October 11, 2017
File No. 02198081.00

Subject: Landfill Gas Well Permanent Decommissioning Request
IESI PA Bethlehem Landfill (Title V Permit No. 48-00027)

FIGURE -1 IESI PA BETHLEHEM LANDFILL - LOCATIONS OF WELLS PROPOSED FOR DECOMMISSIONING

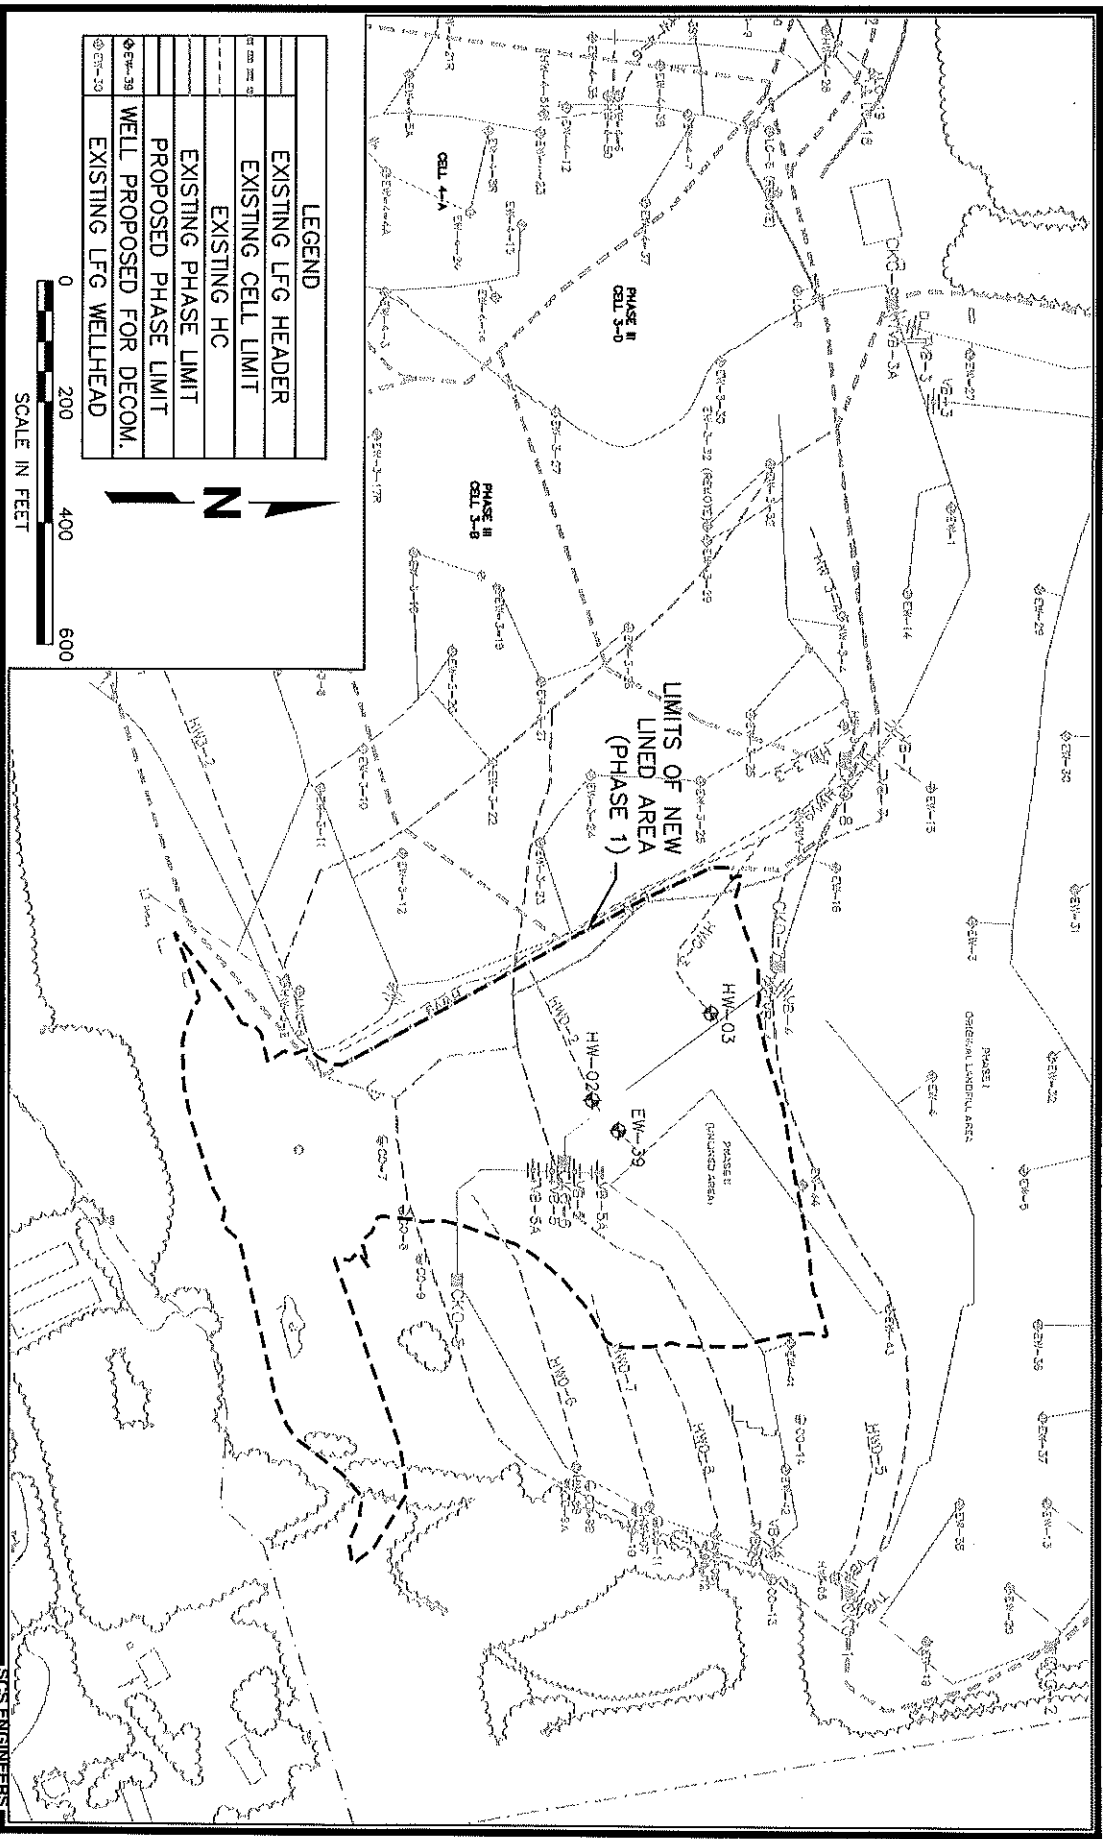
The following wells are proposed for permanent decommissioning: HW-02, HW-03 & EW-39.

These wells are located in the old landfill area and within the limits of the new Phase I membrane liner for the Southeast Realignment and are thus no longer necessary. Gas collection from under the liner will be achieved via a series of new horizontal collectors to be installed with the liner construction, per the landfill's permit. The decommissioning will consist of removing the wellhead and connection to the header piping, and capping and sealing the pipe casing below grade. A site map of the GCCS depicting the wells to be decommissioned is attached as **Figure 1**. Recent monitoring data for these wells is attached as **Table 1**.
